Tennessee Valley Authority, Post Office Box 2000, Spring City, Tennessee 37381

WATTS BAR NUCLEAR PLANT (WBN) - RESPONSE TO NRC REQUEST FOR ADDITIONAL
INFORMATION - CONDUIT FIRE BARRIER FIRE ENDURANCE TESTING PROGRAM
(TAC M63648)

WATTS BAR NUCLEAR PLANT RESPONSE TO NRC REQUEST FOR ADDITIONAL INFORMATION (RAI) CONDUIT FIRE BARRIER SYSTEM FIRE ENDURANCE TESTING PROGRAM

Fig. 3 Plan View

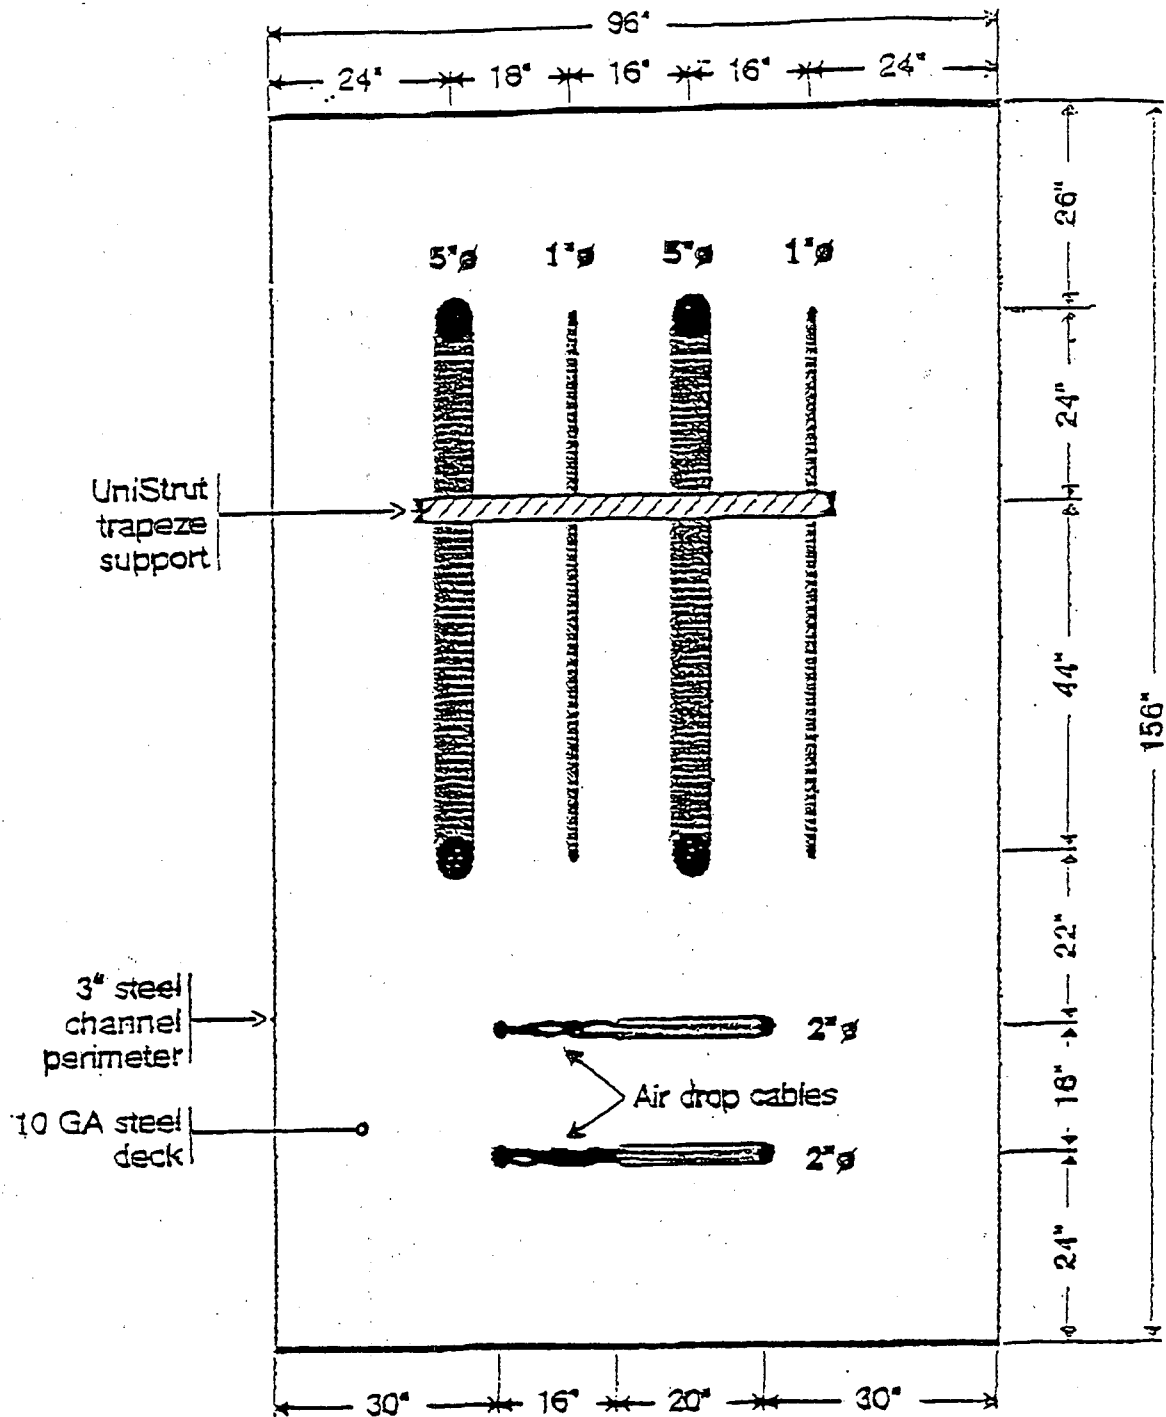
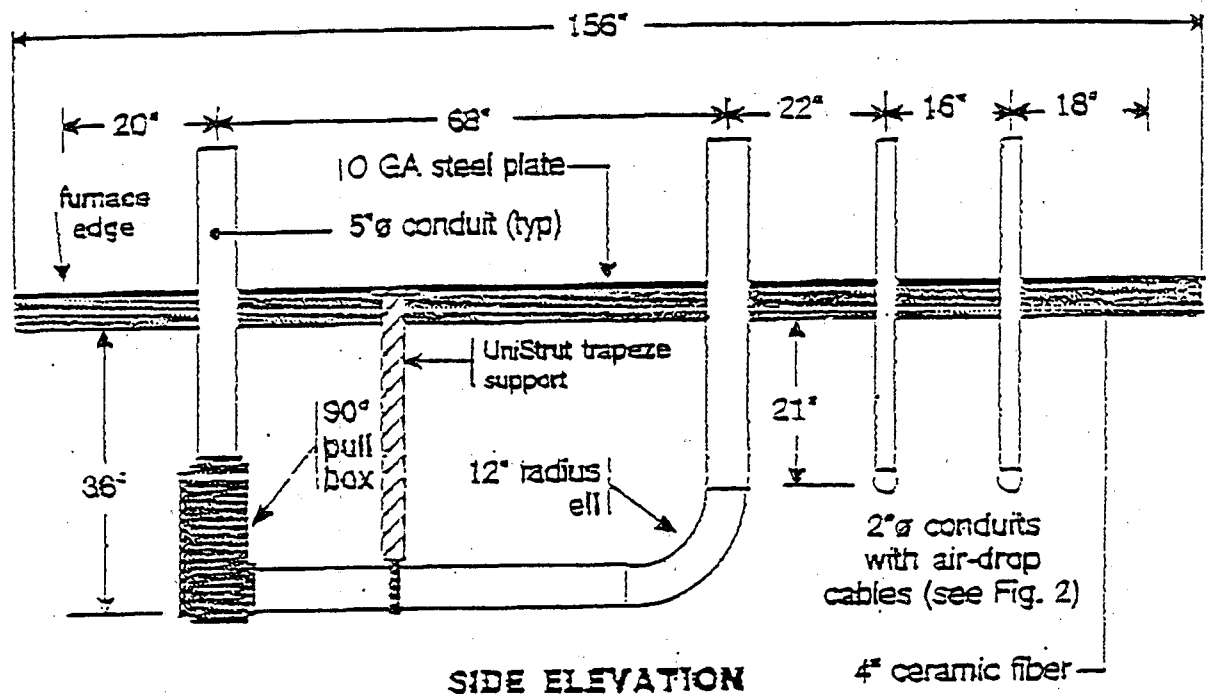
In Figure 3, the applicant provided an overview of its conduit test configuration. In this figure, the applicant identifies the use of a Unistrut trapeze support for these conduits. We request that the applicant confirm that this support configuration is representative of those installed at WBN.

The Unistrut support used in the test specimens is representative of one way in which conduit is supported in the plant. Conduits are also supported by tube steel of various sizes and by fastening directly to concrete. The potential effect of a support which is of importance during fire exposure tests is the transmission of heat to the inside of the fire barrier. TVA considers the tested Unistrut configuration, protected by Thermo-Lag to a distance of 18 inches from the conduit, to be a reasonable representation of the heat transfer which might occur because of plant installations. Additional tests for junction boxes will include installations of conduit mounted to concrete. A temperature profile of Thermo-Lag insulated tube steel (2-inch and 4-inch square tube) will also be obtained during these tests.

THERMOCOUPLE PLACEMENT

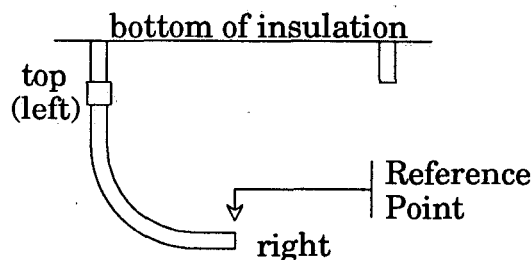
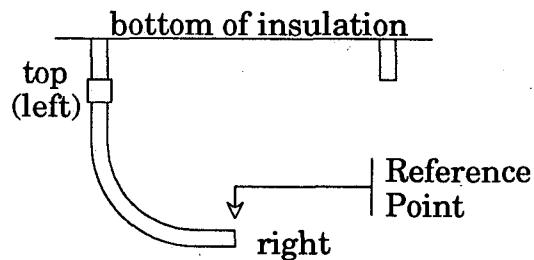
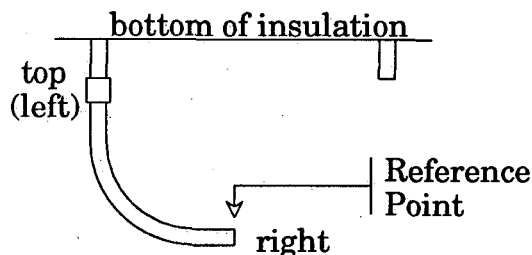
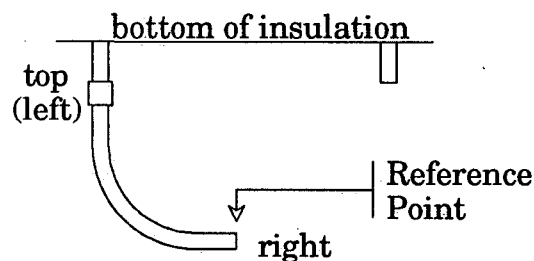
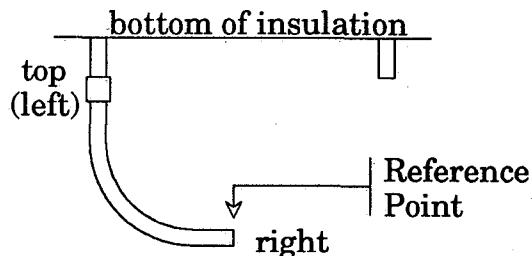
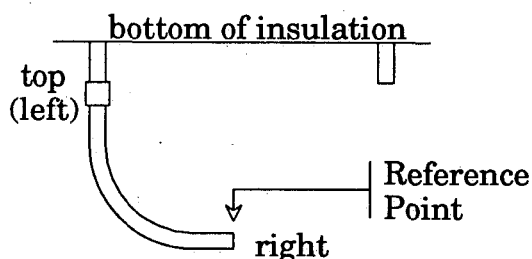
In Section 7.8, the applicant discussed the placement of thermocouples on the test specimens. The applicant indicated that it intends to follow UL 1724 to determine the number and spacing of the thermocouples along the raceway. With respect to TVA's test configuration, we need additional information concerning the distribution of thermocouples on the raceway. In order to complete our review, we request details of the thermocouples on the test specimen. In

addition, we need the applicant to discuss how it intends to average the temperature readings of the thermocouple strings and apply this data to the acceptance criteria.

Attachment 2 provides drawings showing the location of thermocouples on conduits. OPL has agreed to provide the specimens in the upcoming tests with a spacing of 6 inches between thermocouples for those on the external surface of the conduits as agreed to in our January 25, 1993 meeting. We have included data sheets showing thermocouple placement for the upcoming tests in Attachment 4. The readings of all thermocouples on the exterior surface of a conduit will be averaged to obtain a value for comparison to the average 250°F temperature rise criterion. In addition, the maximum reading of any individual thermocouple on the exterior conduit surface will be compared to the 325°F maximum temperature rise criterion. If both of these criteria are met, a tested barrier is considered acceptable, and temperatures measured on the bare copper conductor inside the conduit will not be used. If the temperature rise criteria are not met, cable functionality tests will be performed using a maximum internal temperature profile obtained from the thermocouples on the bare copper conductor.
